Tech Tip

From your friends at New York Bus Sales

Product Affected-All American “D3”

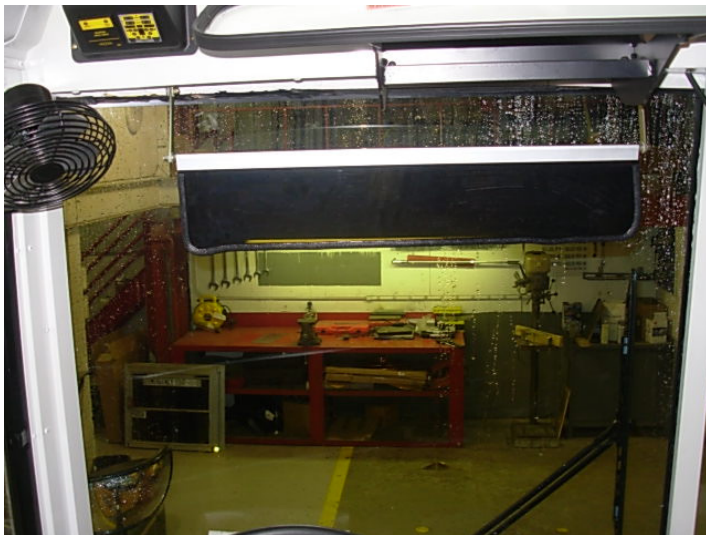
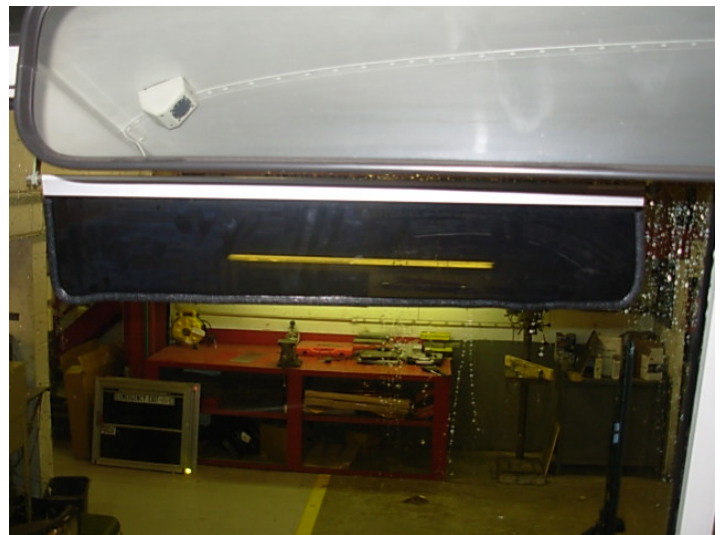
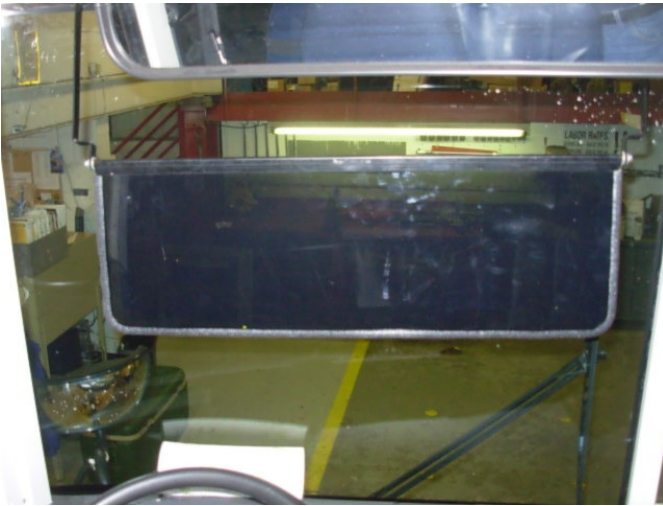
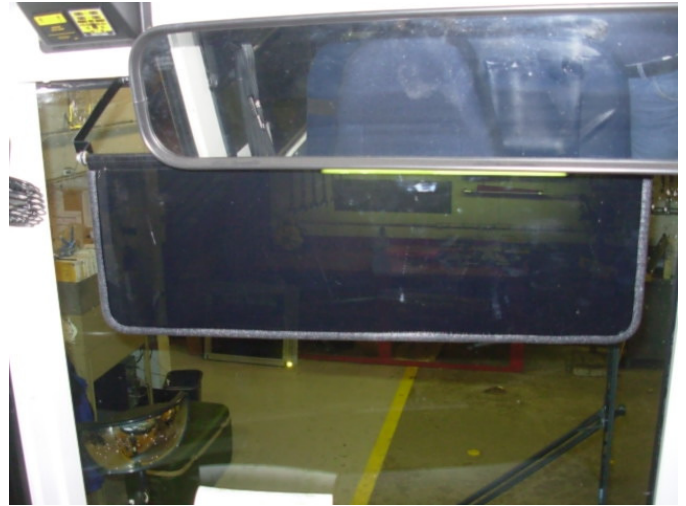
- Complaint -** The sun visor cannot be adjusted to not fully block the sun.
- Cause -** Increased windshield size!
- Correction -** The current production D3 units use the original 6 X 30 visor as pictured in Figures #1 and #2 which may not cover the same area that some drivers require. We have been working with Rosco and have found a larger visor which we feel will further adjust to cover a larger area and will be much more adaptable to drivers. Please look and Figures #3 and #4 as you can see specifically in Figure #4 the space to the left which we heard most about is addressed with this new visor!

PART #81035 - \$33.85
